Peach Bottom Atomic Power Station, Units 2 and 3
Renewed Facility Operating License Nos. DPR-44 and DPR-56
NRC Docket Nos. 50-277 and 50-278

Subject: Extended Power Uprate License Amendment Request – Supplement 13
Response to Request for Additional Information

Attachment 1

Response to Request for Additional Information – AHPB-HP

Figure SRXB 30-1

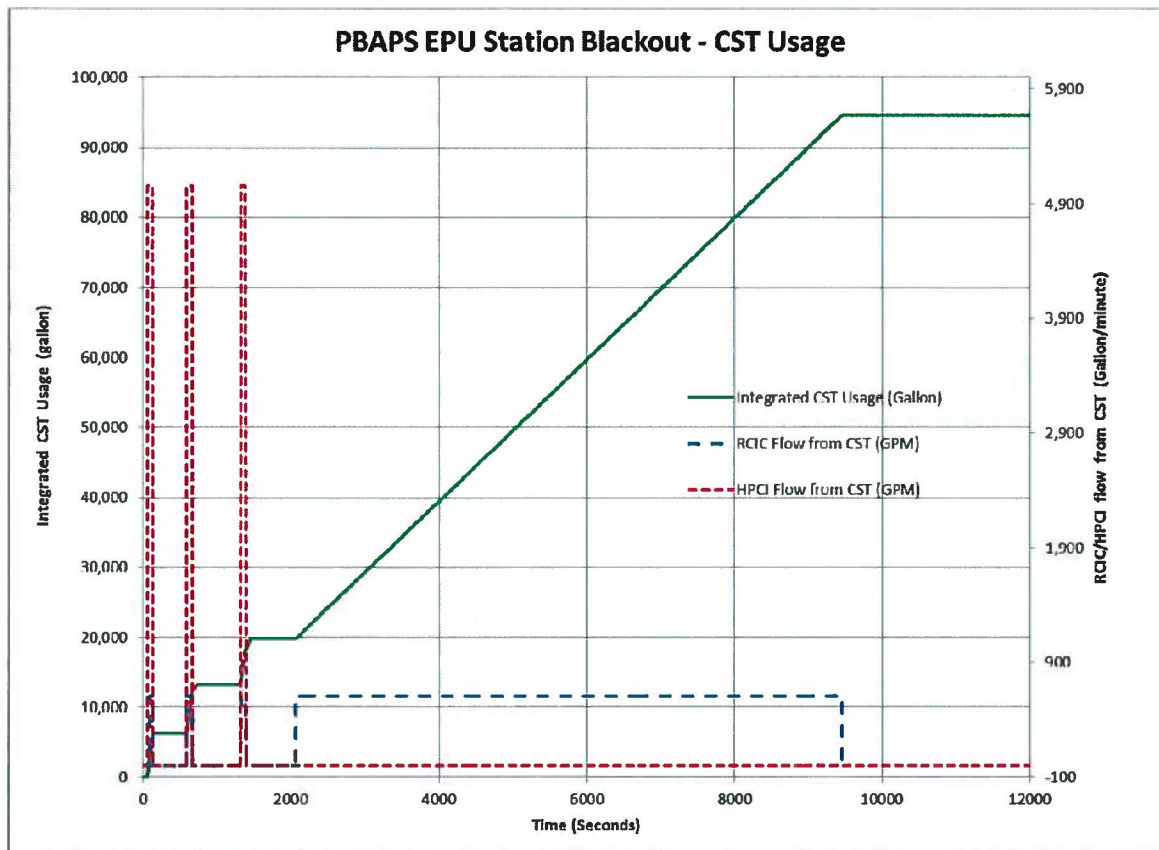
Attachment 9 to the application dated September 28, 2012, describes proposed modifications to PBAPS associated with the EPU. Condensate storage tank (CST) modifications are described in Enclosure 9e to Attachment 9. Section 3.1 of Enclosure 9e describes the addition of a CST standpipe to "ensure a CST dedicated usable volume for the HPCI (high pressure coolant injection) and RCIC (reactor core isolation cooling) pumps for SBO (station blackout), ATWS (anticipated transient without scram), and Appendix R events." This section refers to Section 2.3.5, "Station Blackout," of the Power Uprate Safety Analysis Report (PUSAR³) and states that "[t]he CST volume needed for SBO at EPU conditions is approximately 94,570 gallons." Provide the EPU SBO analysis that concludes that this is the CST inventory required for mitigation.

Figure SRXB 30-1 is a plot of the PBAPS SBO analysis results for integrated CST usage with an overlay of the HPCI and RCIC makeup duty times with pump suction aligned to the CST. This plot from the analysis results demonstrates the conclusion that the CST volume needed for SBO at EPU conditions is 94,570 gallons.
